IRIS Touch Firmware Enhancements and Additions

From Version 1.11 to Version 1.12.3

Dialler checking for updated software

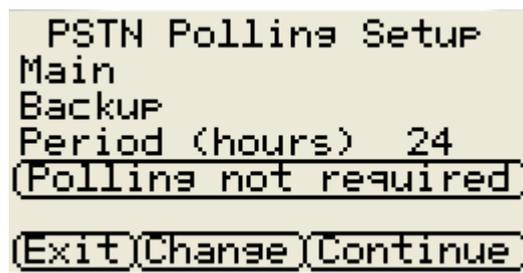
As part of the installation wizard, the dialler now makes a call to Chiron's reflash server to check whether it has the latest firmware installed. If there is new firmware available, the installer is given the option of updating the dialler immediately.

Note that if Chiron's reflash server cannot be reached, the operation can just be skipped.
